STATION EQUIPMENT
JACKS, PLUGS, AND ADAPTERS
IDENTIFICATION, INSTALLATION, AND, SERVICE

1.001 This addendum supplements Section 461-630-100, Issue 12. Place this pink sheet ahead of Page 1 of this section.

1.002 This Addendum is issued to add information on the **700A4** plug.

Fig. 27.1 — **700A4** Plug With Conductors Terminated

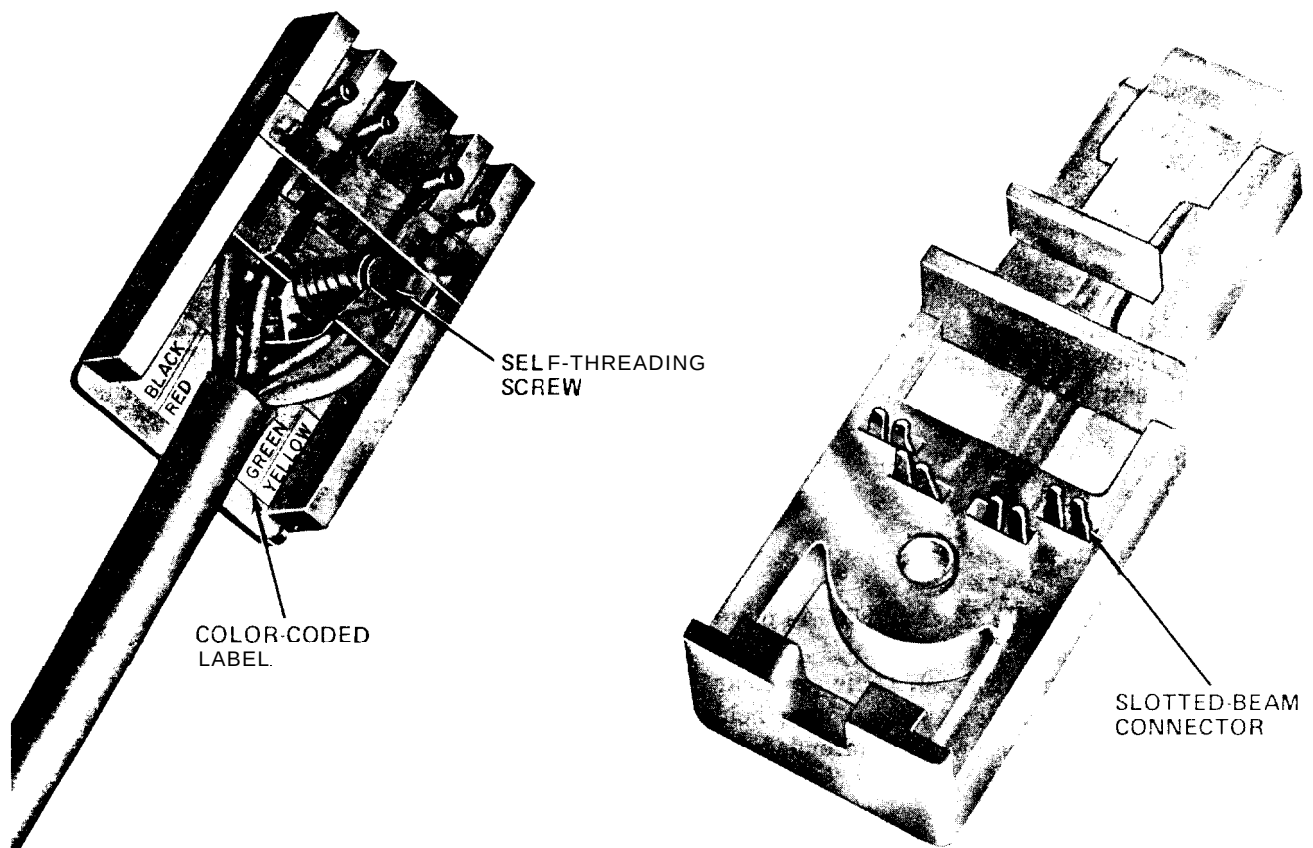
2.002 On Pgge 7, paragraph 2.21.1 add **700A4** plug.

2.002 On Page 15, paragraph 2.49 add Fig. 27.1 **700A4** Plug.

2.21.1 The **700A4** plug (Fig. 27.1) is a clear polycarbonate two-piece molded plug held together by a self-tapping screw. It is intended for

use at one end of a length of quad station wire to permit it to be plugged into a modular telephone jack. The contacts of the plug are connected to four slotted-beam connectors which will be forced through the insulation of the individual conductors when they are properly aligned and the sections screwed together.
